**OIL SANDS CO-PRODUCTION EXPERIMENTAL PROJECT
SUPPLEMENTAL INFORMATION REGARDING
AEUB APPLICATION NO. 950993
AEP APPLICATION NO. 001-17233**

OCTOBER 1995

Subject: Application No. 001-17233
THE OIL SANDS CO-PRODUCTION EXPERIMENTAL PROJECT
LEASE 7276120T05

This submission is in response to a September 19, 1995 letter from the Alberta Energy and Utilities Board (AEUB) and a September 20, 1995 letter from Alberta Environmental Protection (AEP) to the SOLV-EX Corporation.

Figure A1. Maximum 1-hour average SO₂ concentration (ug/m³) results for the combined operation of the SOLV-EX (3 x Phase II abnormal), Suncor and Syncrude facilities as predicted by ISCST2 (rural dispersion, elevated terrain, SandAlta meteorology).

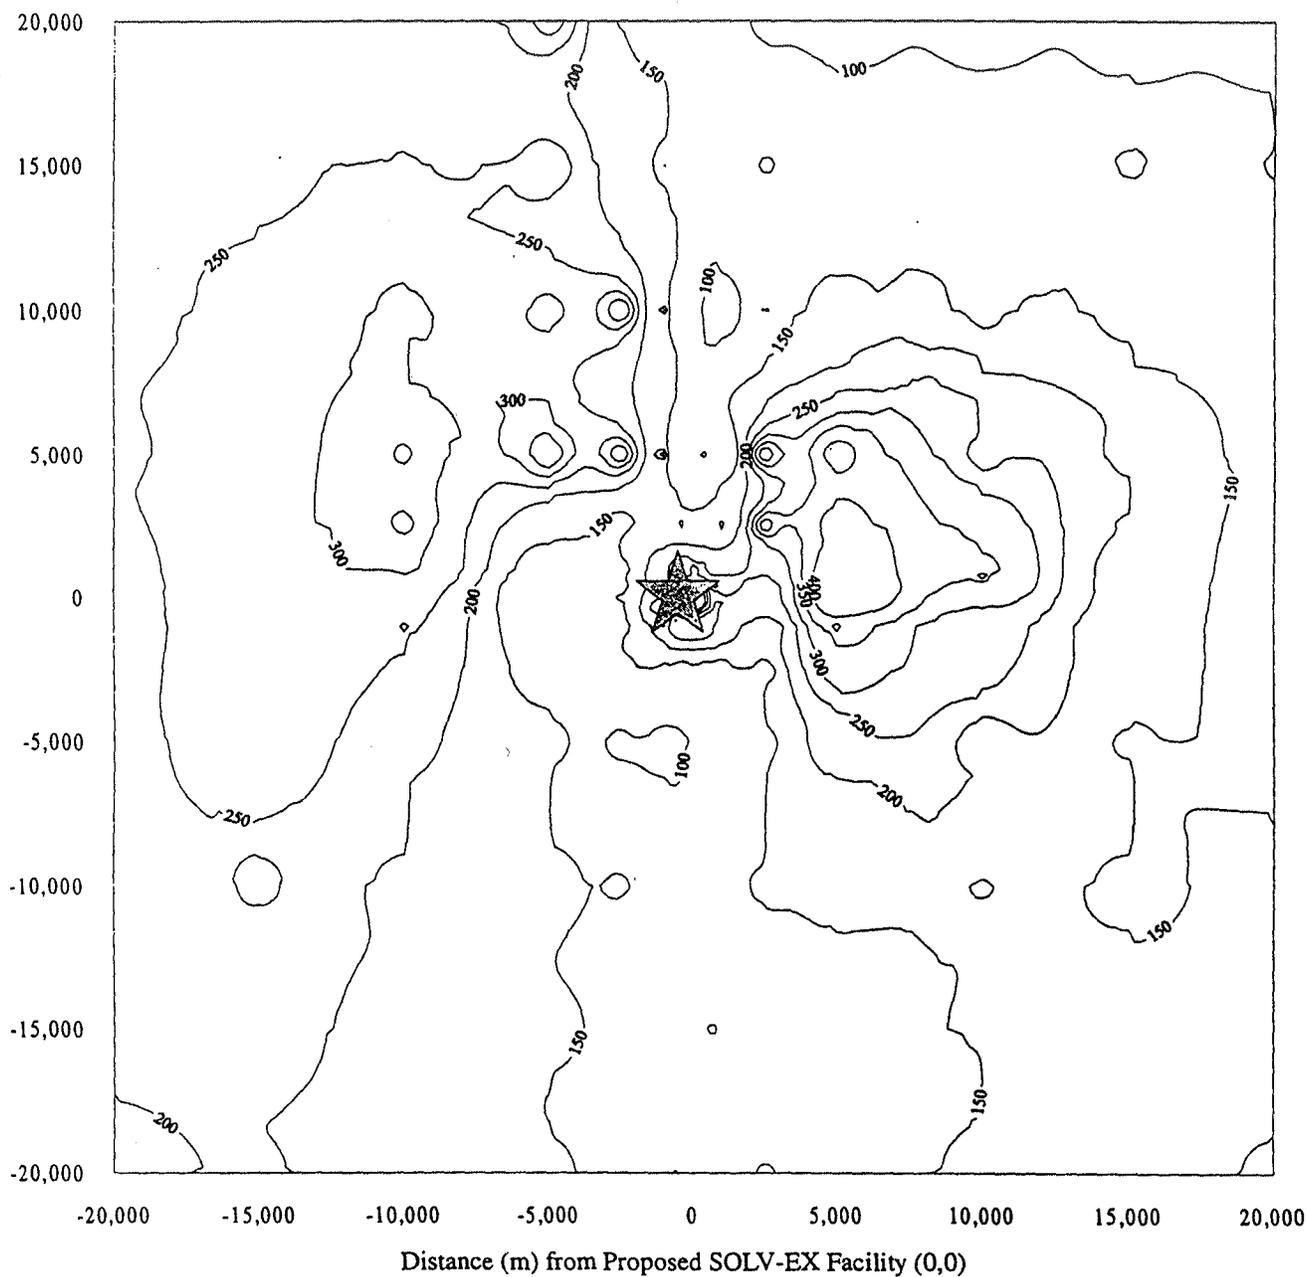
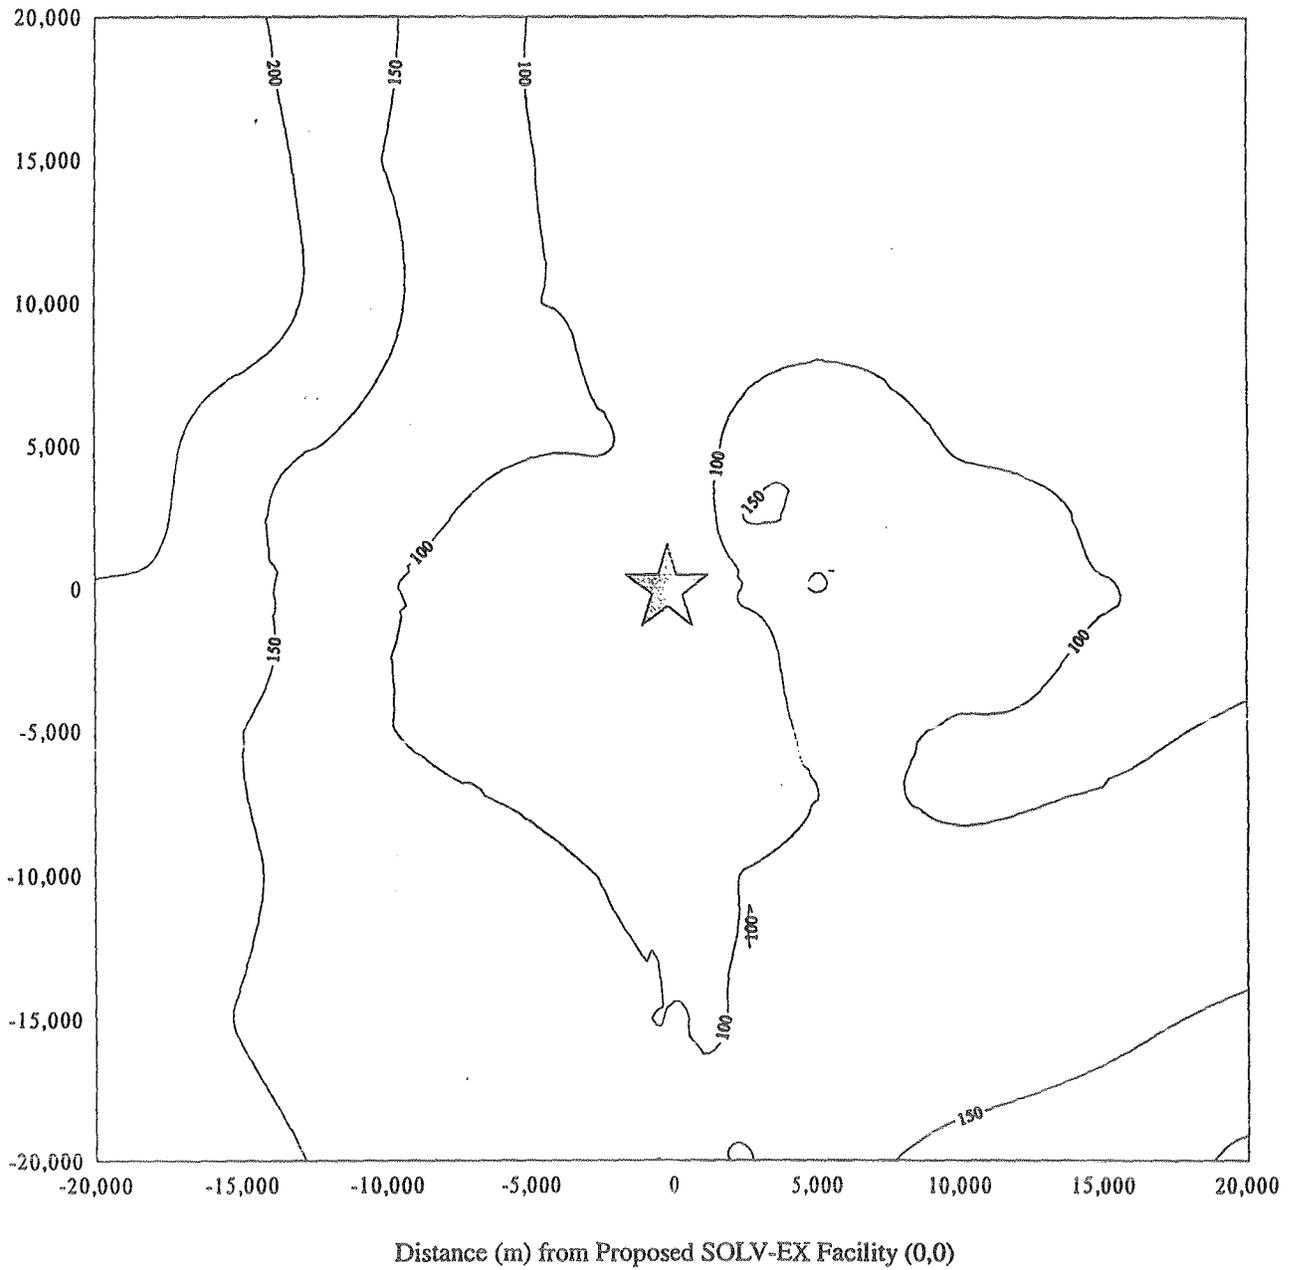
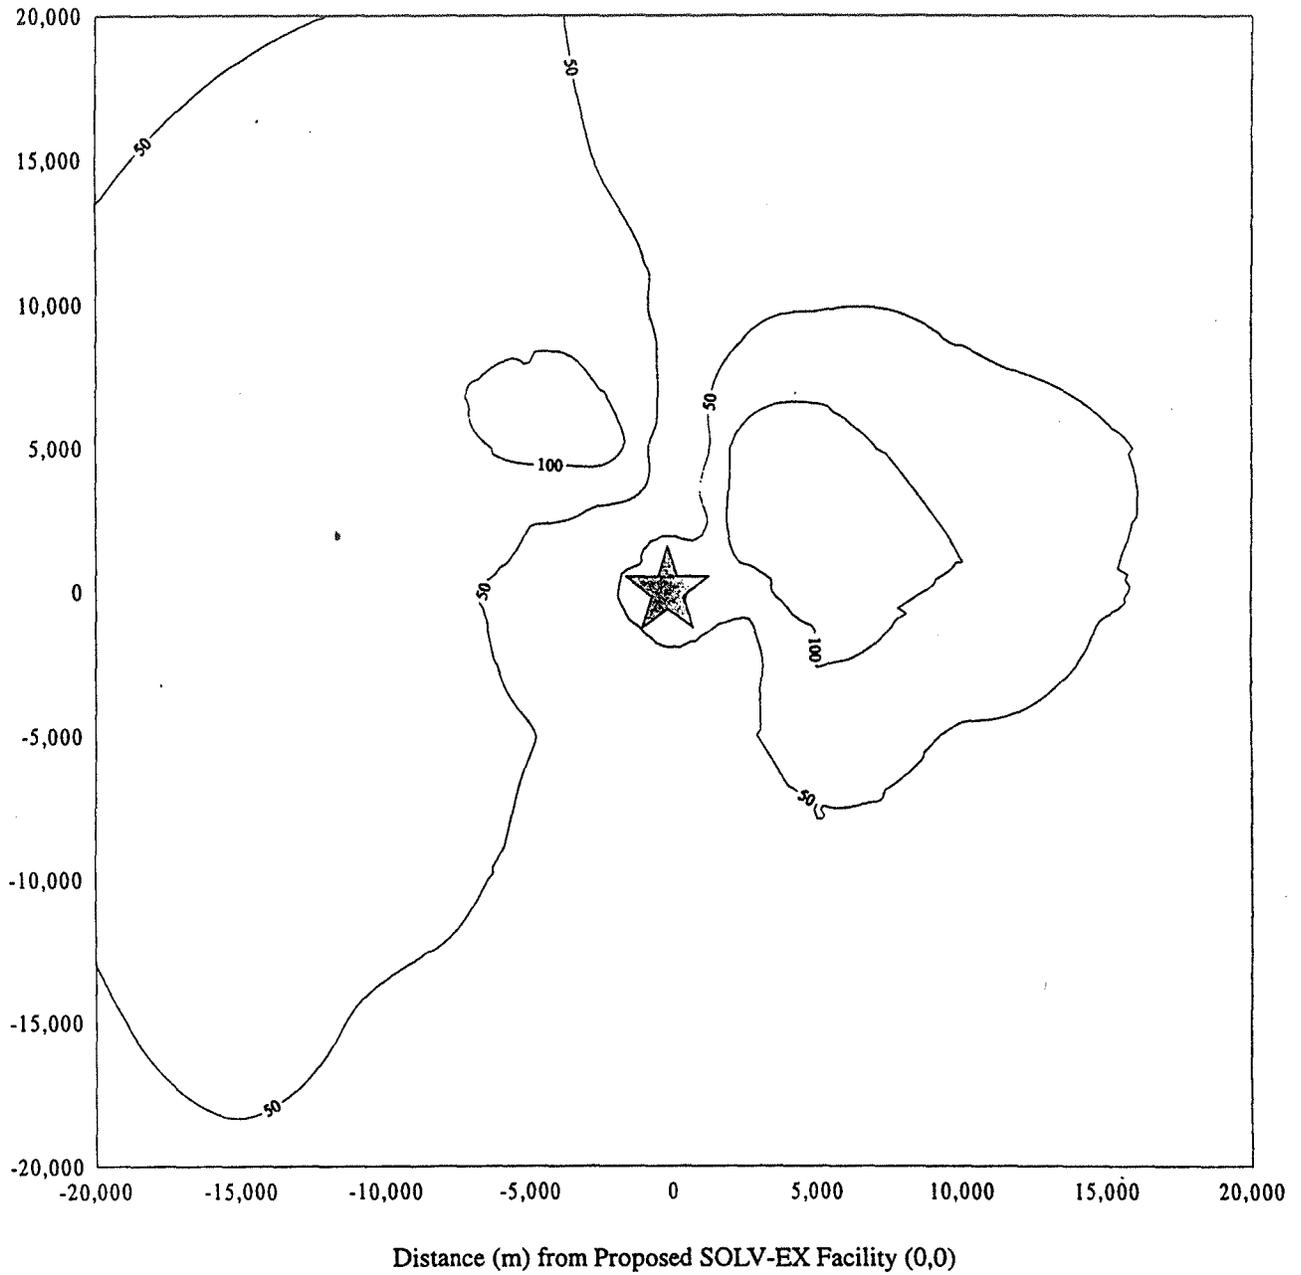
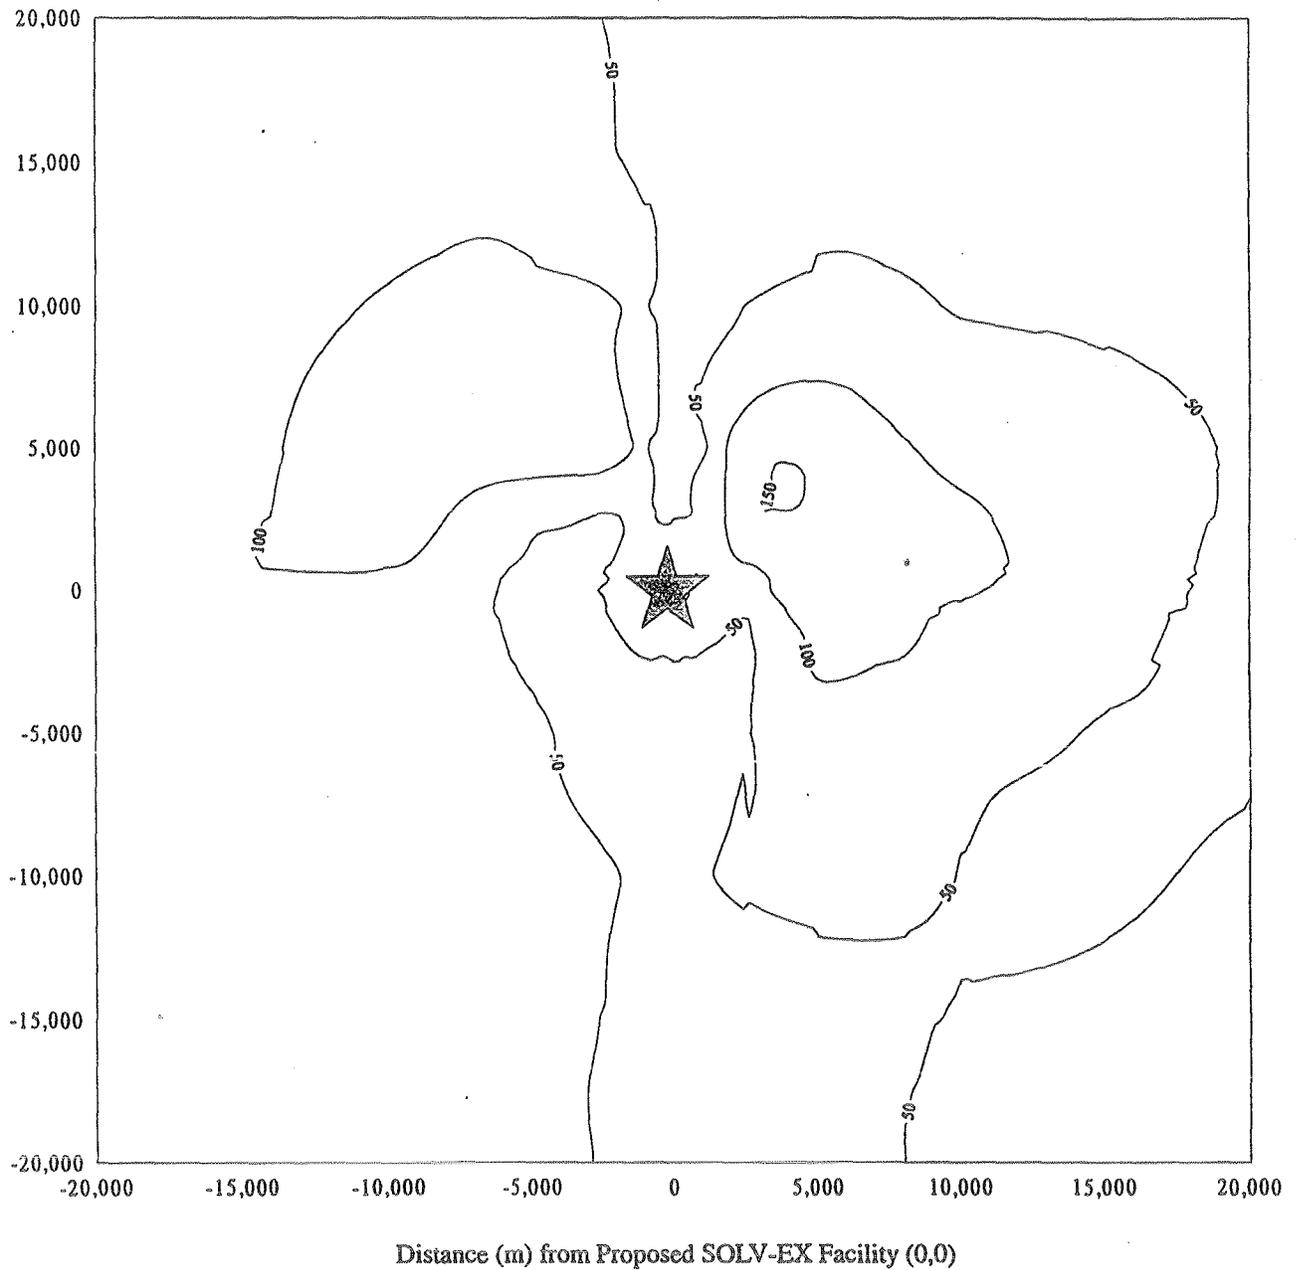
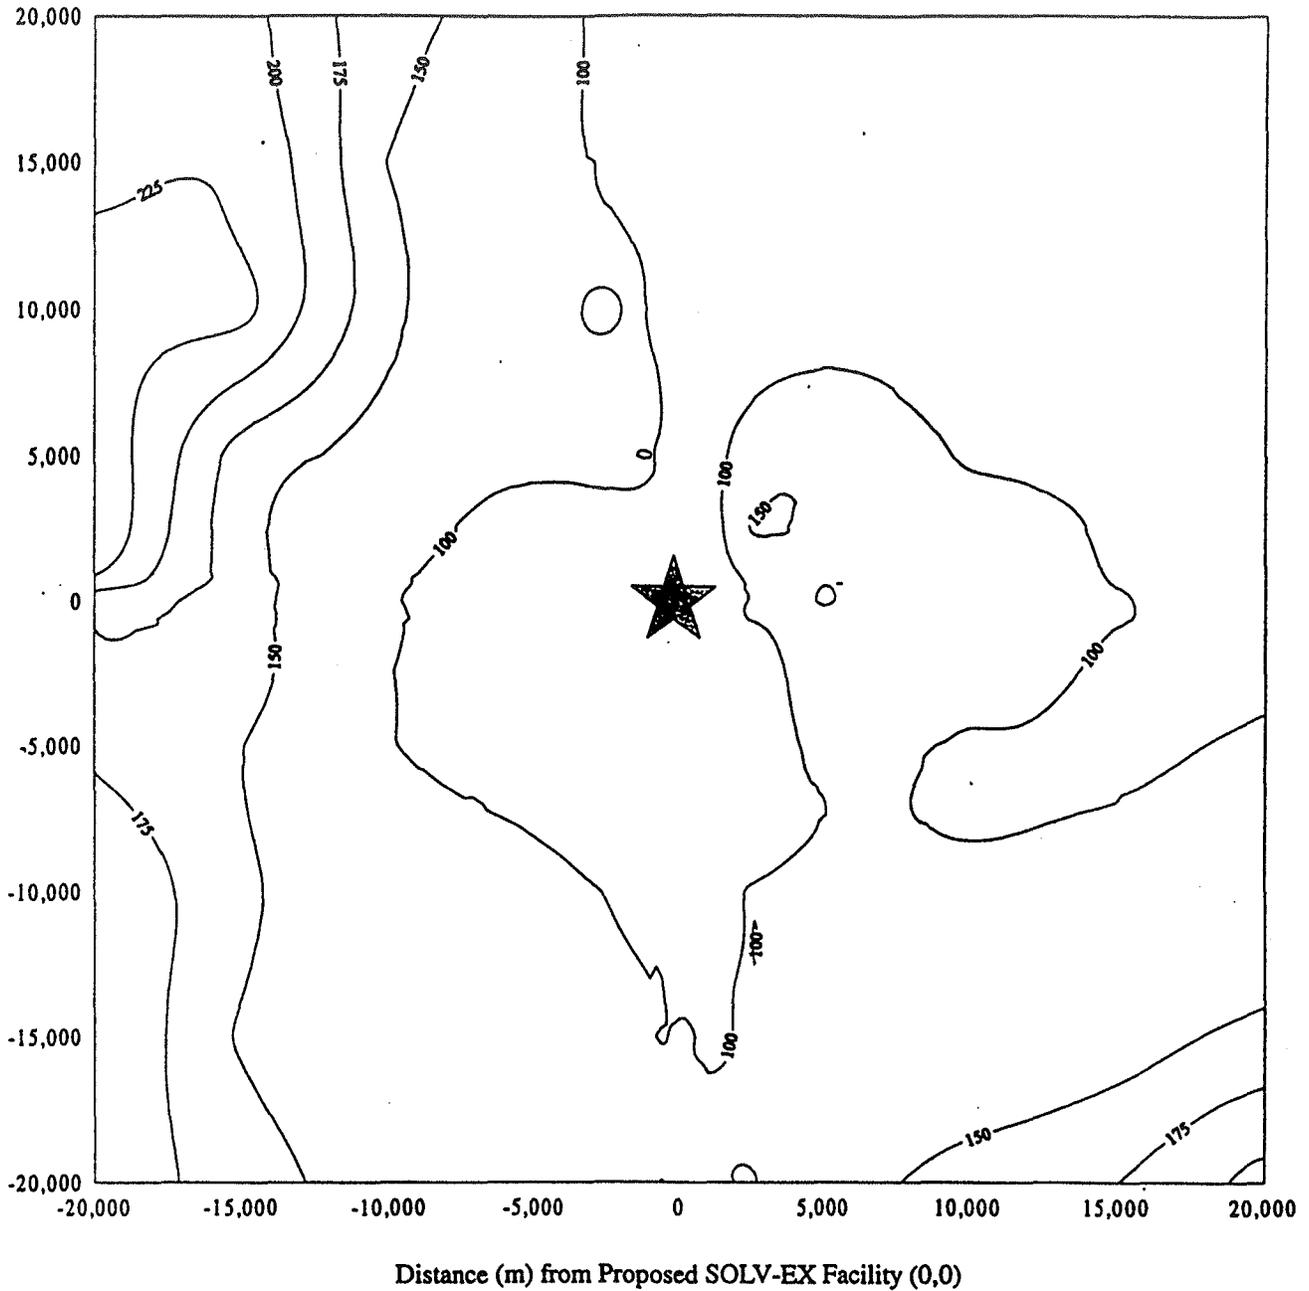
For the dispersion modelling results presented in Table A6 (Appendix A), please clarify what input parameters were used for Suncor and Syncrude air emissions for each of the models.

- The ISCST2 model simulates the effect of Suncor and Syncrude emissions in a 40 by 40 km area centred on the SOLV-EX site (Figure A2 of Appendix A). The maximum predicted hourly SO₂ concentrations in the region is 246 µg/m³. This value occurs 20 km west of the SOLV-EX site and is associated with elevated terrain (Birch Mountains). A secondary maximum of 155 µg/m³ is also associated with elevated terrain (Fort Hills, 5 km northeast of the SOLV-EX site). All the maximum SO₂ values shown in the figure are associated with southerly winds.

- The ISCST2 model was re-run with the SOLV-EX normal and abnormal emissions (Figures A3 and A4, respectively) for both Phase I and Phase II. In Phase II, the maximum value associated with the **normal** case is 146 µg/m³. This maximum is associated with Fort Hills and occurs 3.5 km to the northeast of the proposed plant site. The maximum value associated with the **abnormal** case is 149 µg/m³ and this value is predicted to occur 5 km to the northeast.

- The ISCST2 model was re-run using Syncrude and Suncor emissions with SOLV-EX normal and abnormal emissions, respectively. Figures A5 and A6 show the results. The addition of the SOLV-EX operation does not change the maximum predicted value of 246 µg/m³ which is predicted to occur 20 km west of the proposed SOLV-EX site.

together with the Suncor and Syncrude SO₂ emissions. The result is shown in Figure A1, where the design guideline is 450 µg/m³ as described by the above presented equation. In order to determine the maximum ambient SO₂ guideline for SOLV-EX, each of the sources was modelled individually at the meteorological conditions associated with the maximum prediction (shown to occur in the Fort Hills area, approximately 3.5 km northeast of the SOLV-EX site). From this exercise, it was determined that the contribution from Suncor and Syncrude was zero under the conditions causing the maximum in the vicinity of the SOLV-EX site. Thus, from the equation, the effective ambient SO₂ limit for SOLV-EX is 150 µg/m³.
